SERVICE BULLETIN

SUBJECT: Barrels of architectural sex bolts *may* come into contact with shim plate and causing an improper fit or *may* cause excess vibration on lock. This occurs on certain wood doors which are less than 1.75" thick or when sex bolt screw has been over-torqued and wood door is compressed.

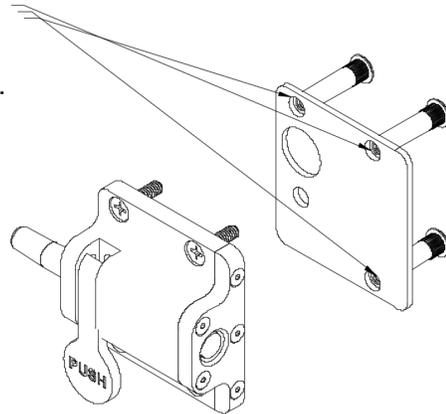
Barrels of architectural bolts should NOT come into contact with shim plate on occupancy side of door.

Repair shim plate by drilling 3 - 13/32" holes through plate. This will provide for ample headspace at end of architectural sex bolt barrel. Alternatively, shim plates may be exchanged for a new one by contacting us at service@teacherlock.com

Drill $\frac{13}{32}$ inch hole
in shim plate
in three (3) places.
